Re: Solicitation # 16-101

Interpretive Exhibit Fabrication and Installation for the Pinelands Visitor Center

Addendum #1

Addendum #2

Exhibit Plan

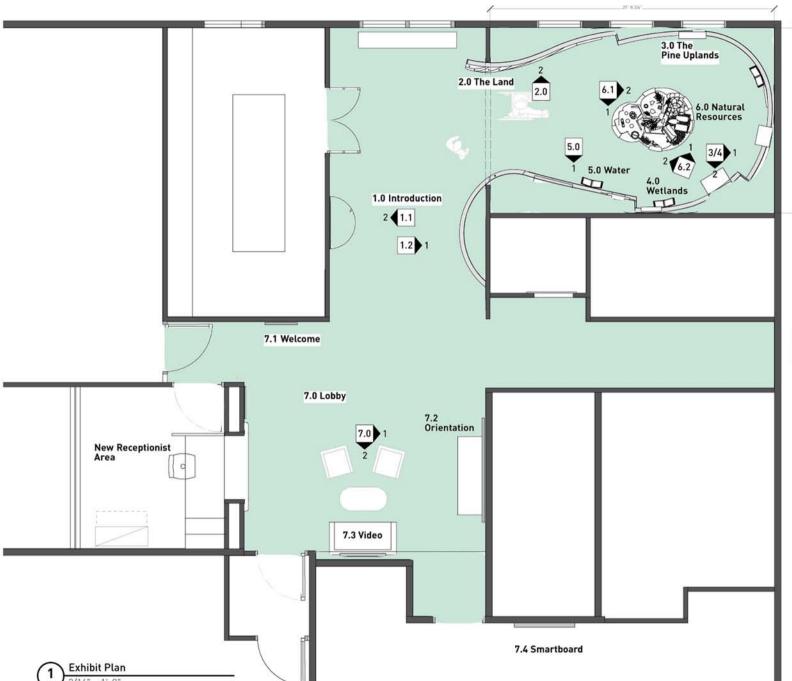
The Contractor is also responsible for painting all walls and ceilings in the exhibit space. The Contractor must widen the opening of the existing, 316-square-foot exhibit room to accommodate the new exhibits (opening the existing doorway to 9'-5" wide and 93" tall), as shown in the Exhibit Design Plan.

In addition, the Contractor must remove two existing windows on the interior library wall. The Contractor must hang drywall over the two windows. The Contractor also must relocate the doorway on the library (expanding it to 72" wide), as noted in the Exhibit Design Plan. The Contractor must install a double French door on the library, unless the Contractor identifies a suitable substitution. The French doors must be natural, clear-finished hardwood.

The Contractor must move the existing "founders/dedication plaque" from its current location, as shown in the Exhibit Design Plan.

First Floor Blueprint

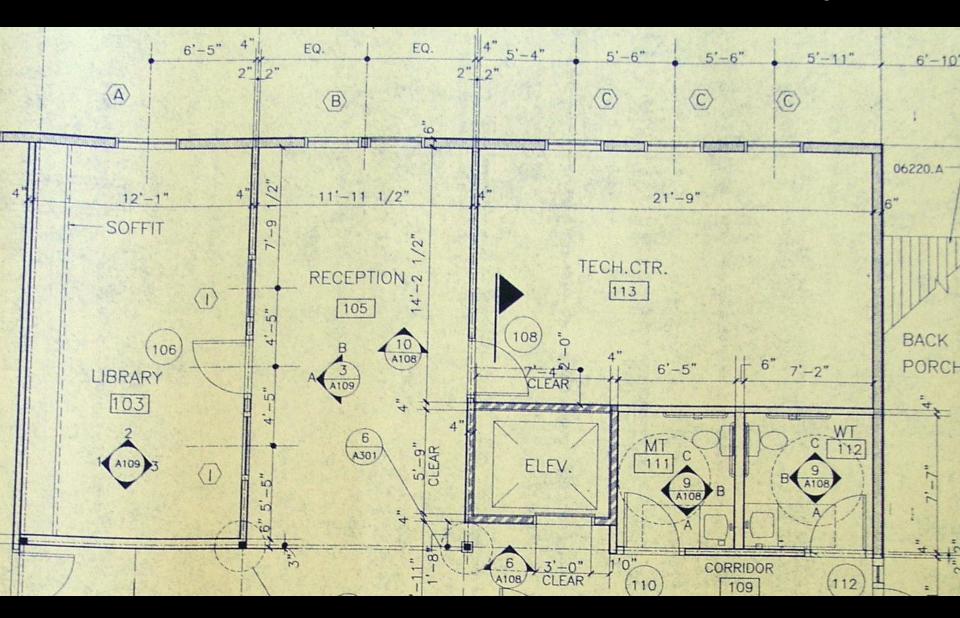
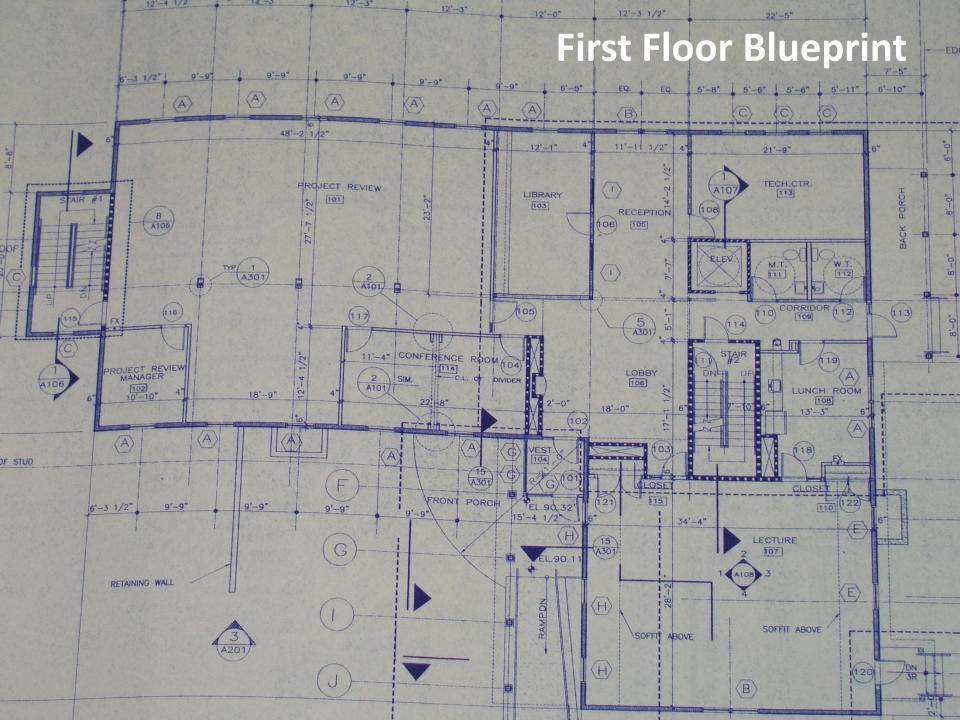
*Note:

The Contractor must install new flooring and must paint the walls and ceilings of the Exhibit Space.
